Meeting Notes

Jefferson County – Courthouse/Sheriff's Building Renovation and Additions

Project No. 2020.01.00 January 11, 2022

Purpose: Discussion to clarify the Scope Of Work for the project.

WINDOW REPLACEMENT FIRST FLOOR PLAN

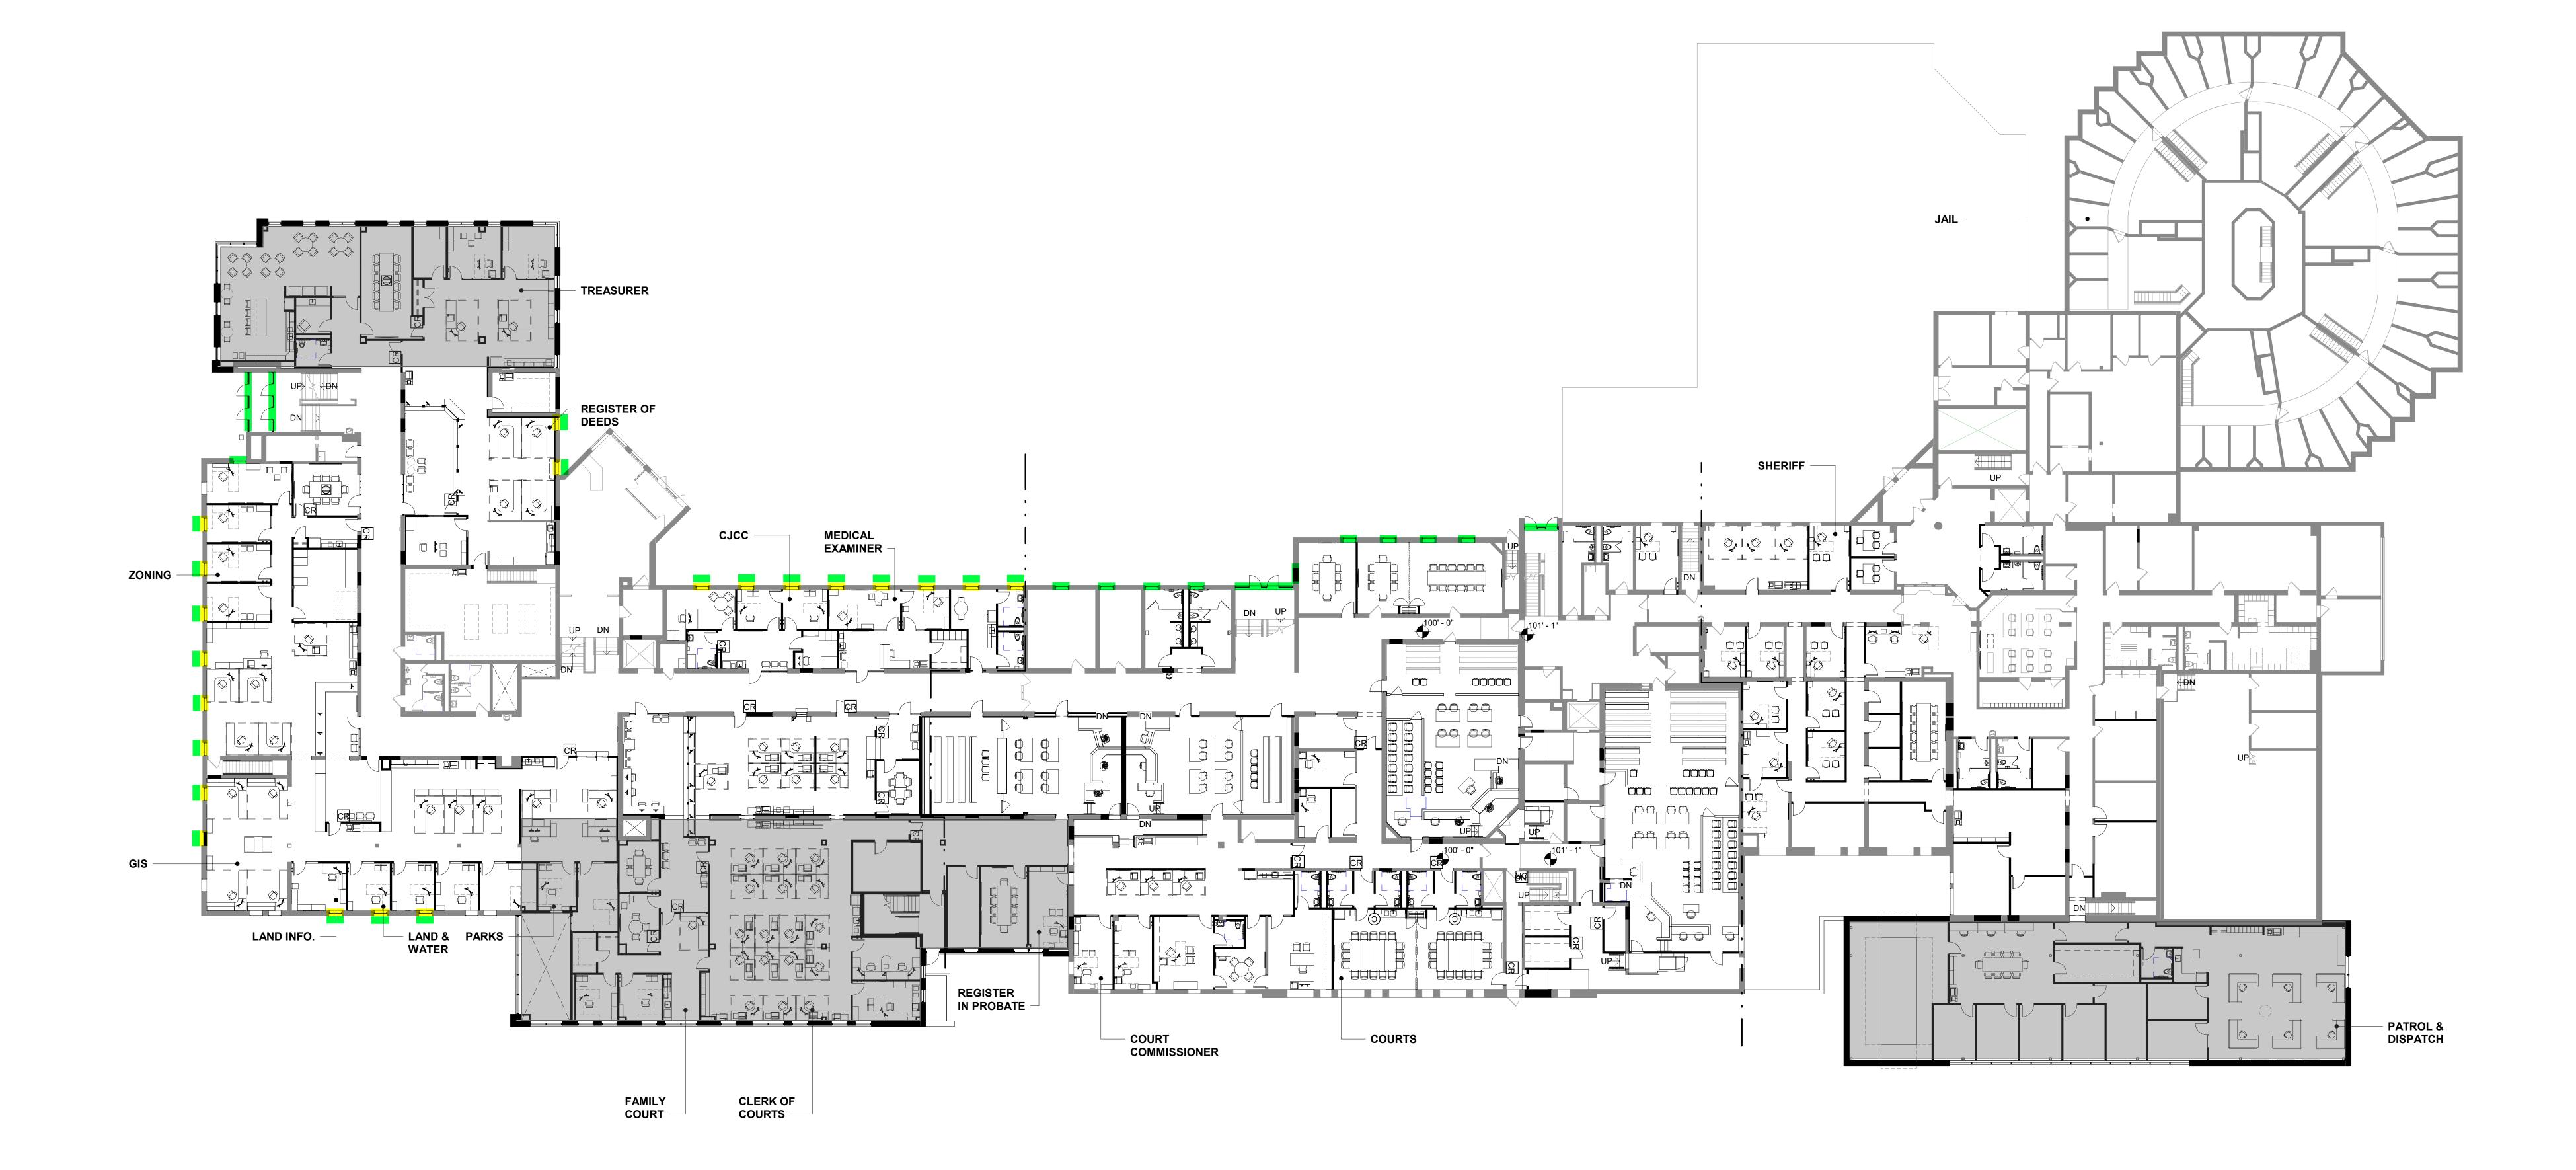
- a. See the attachment for the extent of window replacement.
- 4. Hardware replacement at all non-detention doors: (Currently not in project scope)
